KINROSS GOLD CORPORATION LUPIN OPERATION

2005 GEOTECHNICAL INSPECTION PERIMETER TAILINGS DAMS

LUPIN MINE NUNAVUT

PROJECT NO.: 0256-011-01
DATE: OCTOBER 7, 2005

Long Term Plot for Deep Nodes in D1A-00-01
(Crest of Dam 1A, South End)

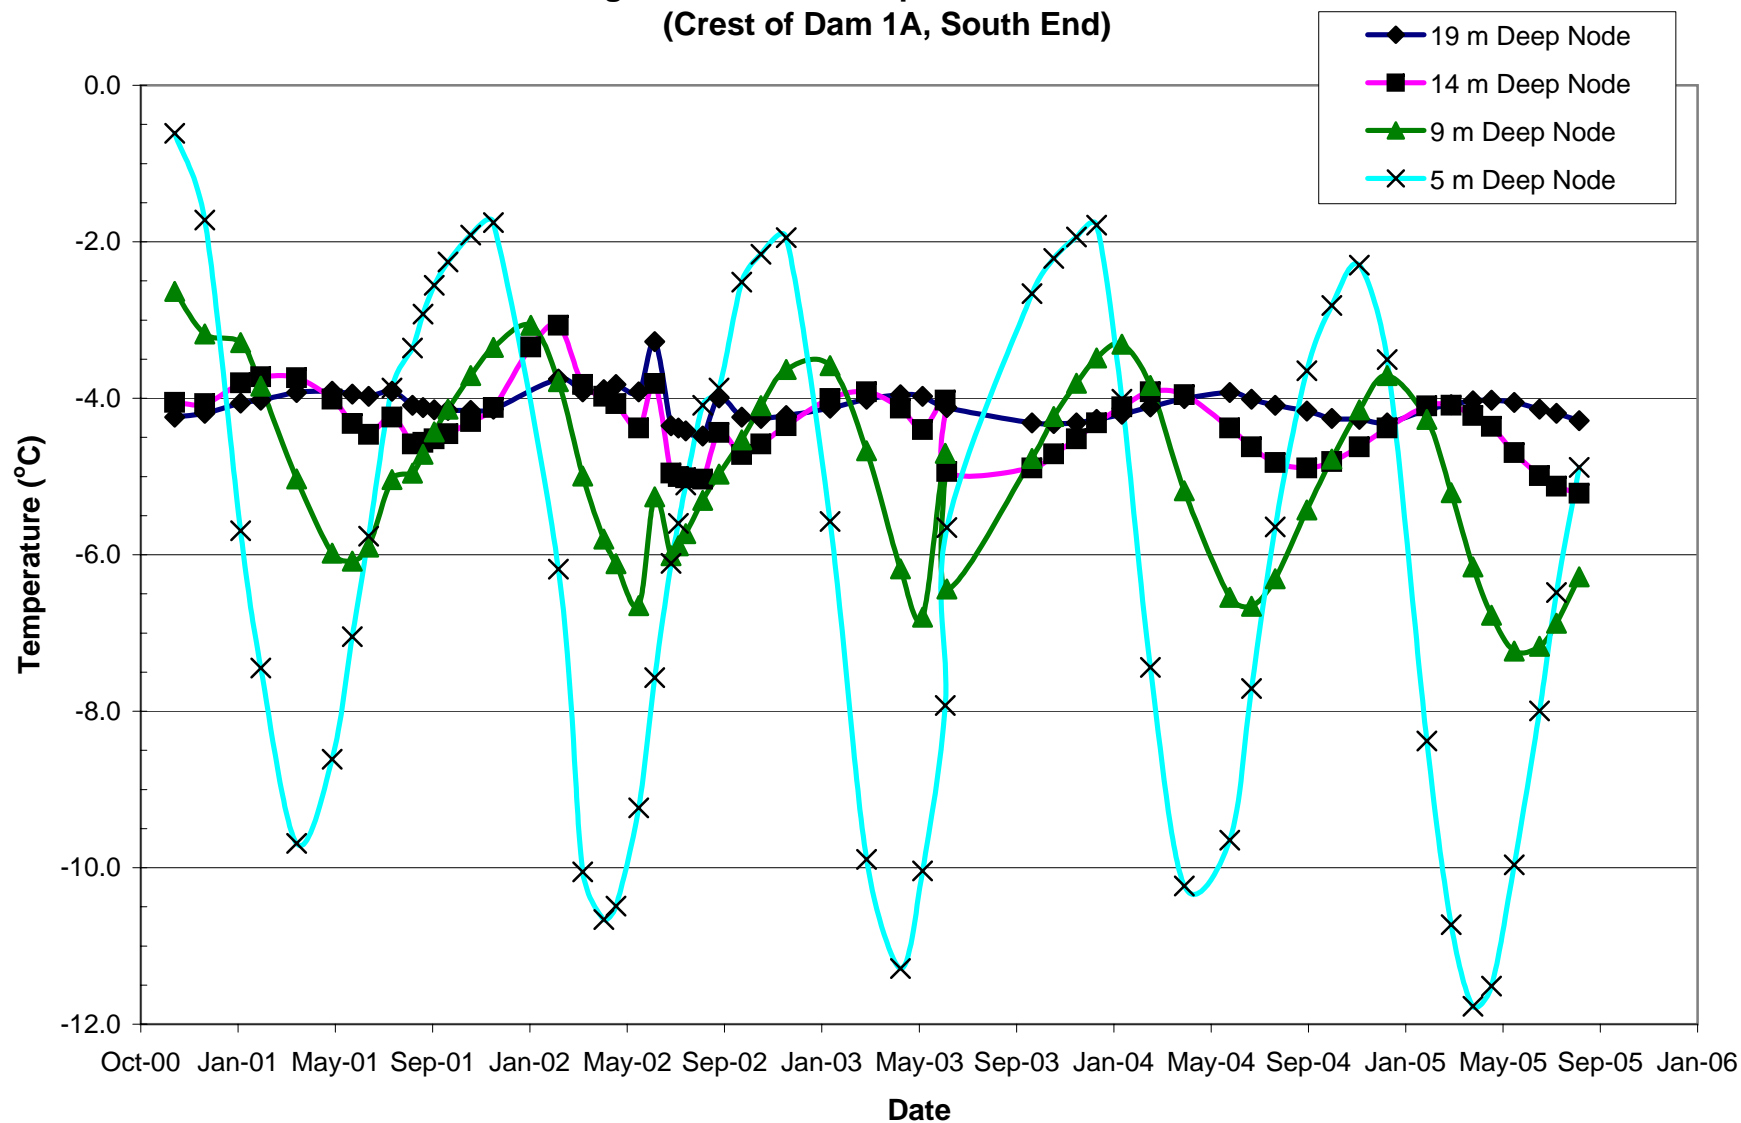
LOCATION:	West side of Pond 2.
FUNCTION:	Major perimeter closure for water retention; carries siphon pipes for water decant system.
LENGTH:	250 +/- m
MAX HEIGHT:	8 m +/- above d/s tundra.
AS-BUILT ELEVATION:	486.27 m
CREST WIDTH AND CONDITION:	7 to 8 m; surfaced with esker material, but not travelled because of the siphons. No significant cracking evident; condition is good.
RIPRAP:	Run of Mine rockfill; broadly graded; good condition. Minor disturbed area (due to construction traffic possibly) in rip rap at the crest edge.
BACKSLOPE:	Approx. 1.5H:1V; variably armoured with cobbles and boulders; no evidence of cracking.
TOE BERM:	No significant cracking evident; condition is good.
SEEPAGE:	No evidence of seepage.
INSTRUMENTATION:	<p>Thermistor D1A-00-1 is located in the crest, just south of the mid-point of the dam. All nodes below 5 m depth are subzero. Nodes below depth of 9 m (situated approximately below the embankment fill) are equal to or colder than -4°C with no signs of significant warming.</p> <p>Thermistor D1A-00-02 is located in the crest towards the north end of the dam. All nodes below 5 m depth are subzero with no indications of warming at depth. Nodes below a depth of 10.3 m appear to be colder than -4.0°C.</p>

CONCLUSIONS: The dam is in good condition with no evidence of seepage passing through or beneath the dam. Monitor instrumentation regularly and visually inspect downstream toe as Pond 2 level increases.

Long Term Plot for Deep Nodes in D2-00-2
(Downstream Side of Crest of Dam 2, North End)

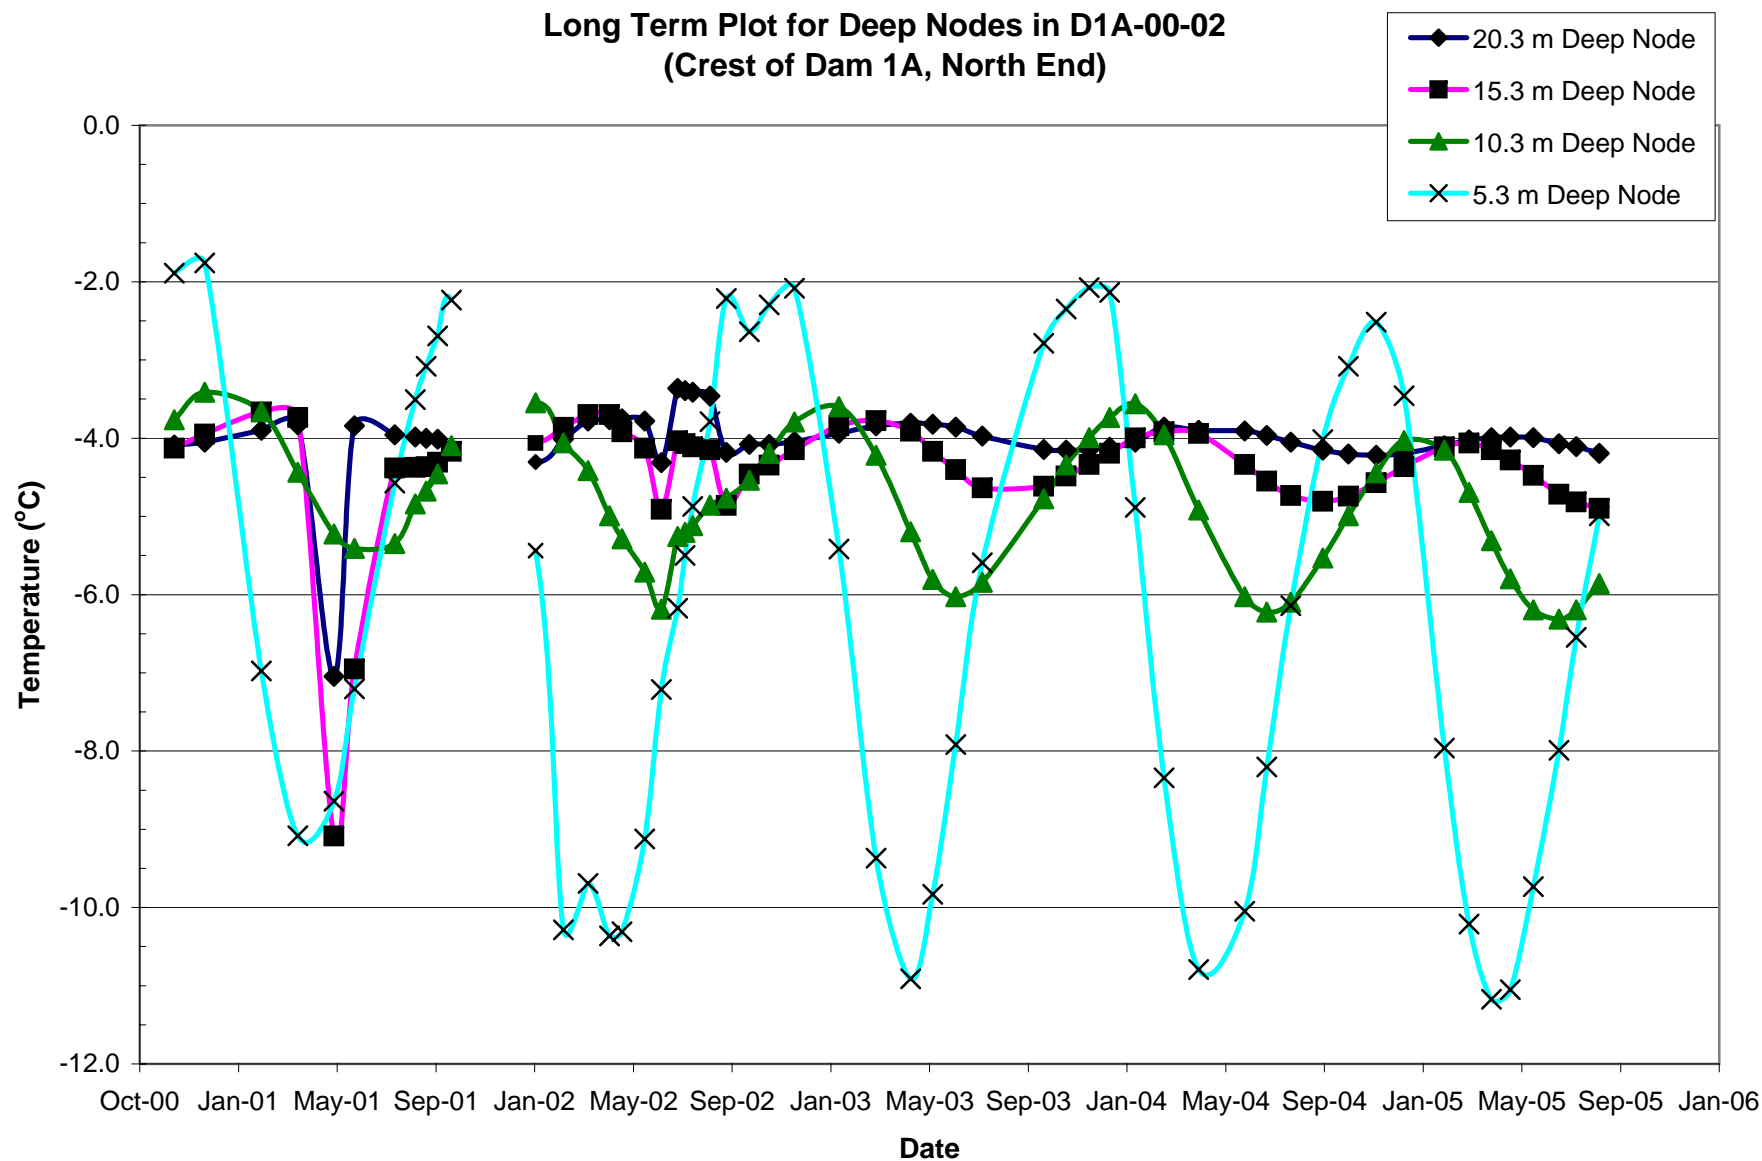
LOCATION:	North end of Pond 2.
FUNCTION:	Major perimeter closure for water retention; natural pond downstream of the dam.
LENGTH:	350 +/- m
MAX HEIGHT:	5.5 +/- m above d/s tundra.
AS-BUILT ELEVATION:	486.30 m
CREST WIDTH AND CONDITION:	Approx. 6 m; surfaced with esker material and used as the primary traffic route. Crest condition is good; no cracking is evident.
RIPRAP:	Run of Mine rock forms convex-upward, gently sloped upstream face; minor erosional scarps formed at previous higher water levels; good condition.
BACKSLOPE:	Approx. 1.5H:1V; a thin (< 1 cm) layer of tailings has been deposited at the toe of this dam.
SEEPAGE:	Seepage (likely resulting from active layer drainage rather than seepage through the dam) observed discharging at the toe of the northeast abutment where it is typically observed.
INSTRUMENTATION:	<p>Thermistor D2-00-02 is located at the north end of the crest. Temperatures at depth are subzero. Below 5 m depth (approximate bottom of embankment fill), temperatures are colder than -2°C.</p> <p>Thermistor D2-00-03 is situated near the mid-point of the dam. Temperatures below 5 m depth are all subzero. Temperatures below 15 m depth are colder than -3.5°C.</p>

MAINTENANCE RECOMMENDATIONS:	The thin layer of tailings that has been deposited at the toe should be removed and placed within the containment pond.
CONCLUSIONS:	The dam is in satisfactory condition. Continue with vigilant monitoring of instrumentation and visual condition assessment.
